Access Compliance Report

Public Rights-of-Way

(Curb Ramps)

Intersection ID: N/A	Main Street: PIMA_COTTON_DR	Cross Street: KANFER_CT	Location: SW
ADA ID: 346A0C53E13C	Ramp Type: BlendTrans2	Initial Pass/Fail: Pass	Overall Compliance: No
Codes/Mitigation Info/Possible Solution		Field Measurements/Component Compliance	
Severity Score: 10.25

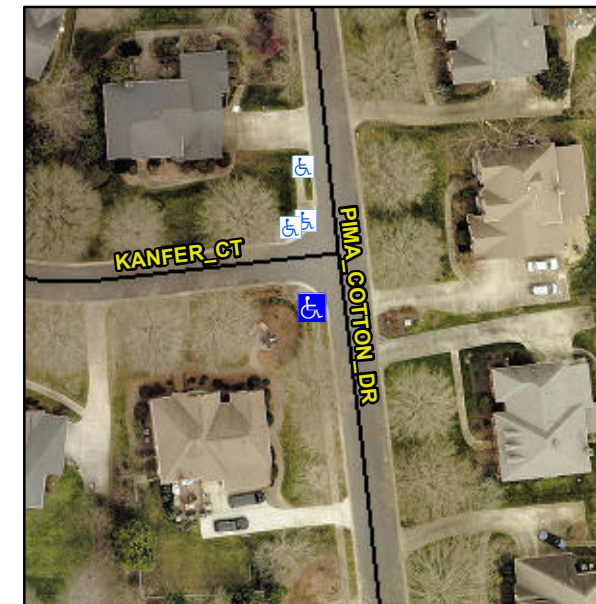
Remove & Replace Curb Ramp With Two New Directional Ramps or Equivalent.

R304.5.3, R305
